RE 820 Civic Center Drive, Clara- Review of Changes to Approved

Plans- Garage/carport and bathroom addition,

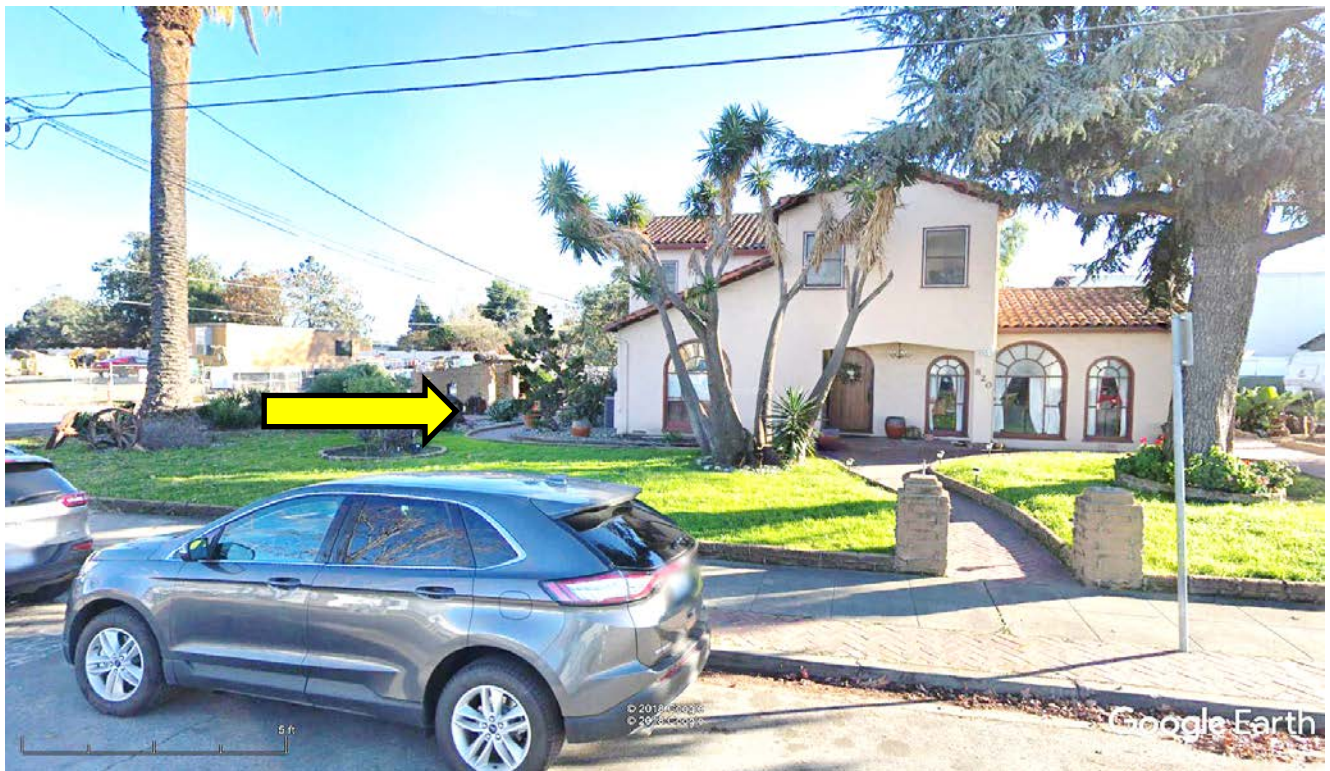
**Figure 2 : Sheet of elevations showing the proposed bathroom addition and the new garage and carport. From the side the garage will screen the lower portion of the house. From the rear, the house is not visible and the new garage/carport will be only slightly visible from Alviso St. From the front the garage/carport is seen set back from the house as a separate structure. The bathroom set back from the front façade of the historic house and is attached to the historic house. This is a minor addition, on a secondary façade and will be covered with plain stucco and roof tiles that are similar to the historic building. The small addition is designed to be compatible with the front view of the historic house.**

**East Side Façade:** This façade is not the primary façade. This façade exhibits little character defining features other than the stucco and tile roof. Prior to the removal of fences and bushes, the lower portion was not visible from Alviso Street. The proposed garage/carport, although not attached to the house will screen the lower portion of the building as viewed from Alviso Street. Screening this portion of the house from public view will not significantly diminish the public's enjoyment of the historic building because the primary façade is the front facing Civic Center Drive and the mass of the building is still visible from Civic Center Drive and Alviso Street. The garage/carport is set back ten feet from the front façade retaining the setting of the primary façade with the expanse of open area at the corner.

The proposed addition of a bathroom is on a secondary façade and removes little historic materials, only the change of one paired window to a door. The window is a common style of many windows in the house and is not individually a character-defining feature.

The garage/carport is a new structure and not attached to the historic building. The proposed new structure does not remove or diminish the character defining- features of the historic building or site. The side yard proposed for the garage is a work area with deteriorated concrete and gravel. These are not character-defining features of the property.

The design for the bathroom (a plain wall on the front façade with a window on the east side, and the typical pitched roof garage/carport do not add conjectural features and do not create a false sense of historical development.
